November 1, 2006

INFORMATION PAPER Skagit River Flood Insurance Study Issues Skagit River, WA

SLOPE SECTIONS "THE DALLES" ON SKAGIT RIVER NEAR CONCRETE

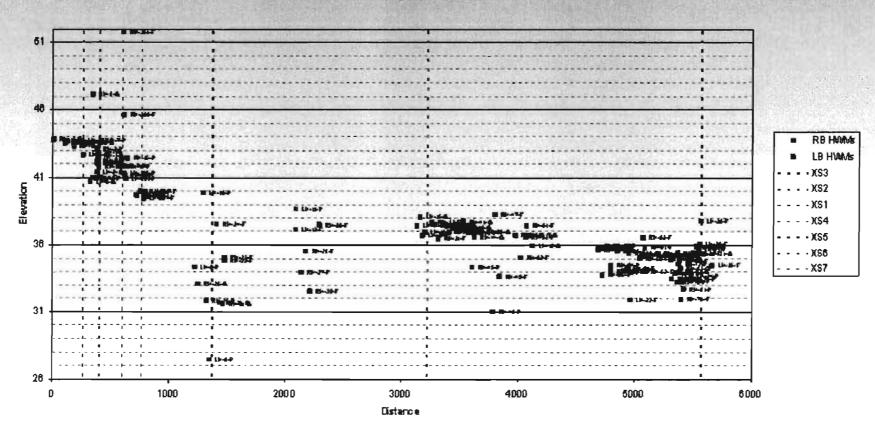
In choosing a slope section, the most important feature is the selection of one where the stream is neither gaining or losing velocity; i.e., selecting a section where the average velocity at the upper end of it (and throughout) is the same as for the lower end. If this is not done, there is a gain or loss in velocity head which cannot be taken care of in the regular formula. In practice, the ideal cannot be attained, but it should be approached as closely as possible. This can be done only by studying the stream in flood.

To counteract the uncertainties involved in velocity head gain or loss, it is advisable to take several sections and average the results obtained from them. In 1922-1923 cross-sections were taken at 618 — 2,749 and 4,655 feet downstream from the mouth of "The Dalles." If not too difficult, it is suggested that for this important checkwork five cross-sections be taken, say about 700—1,700—2,700—3,700 and 4,700 feet downstream from the mouth of "The Dalles." These five cross-sections will make four stream sections available. It is important that the first one of these below "The Dalles" be far enough below so that all of the velocity head gained in "The Dalles" is lost; i.e., that the water has at least reached its maximum level resulting from the loss in velocity head.

Another feature of some importance, although how much is uncertain, is the amount of surging in the stream at the ends of the sections during the crest of the flood. Manifestly the only elevations available, when the flood crest is based on high water marks, is the crest of the surges, whereas what is needed is the mean level of the water at the time of the flood crest. Information as to this feature can be obtained by determining the amount of surging at the cross-sections for a lower flood, and then by means of the relation of the surging at the water stage records for both floods, determine the surging for the higher flood at the cress-sections.
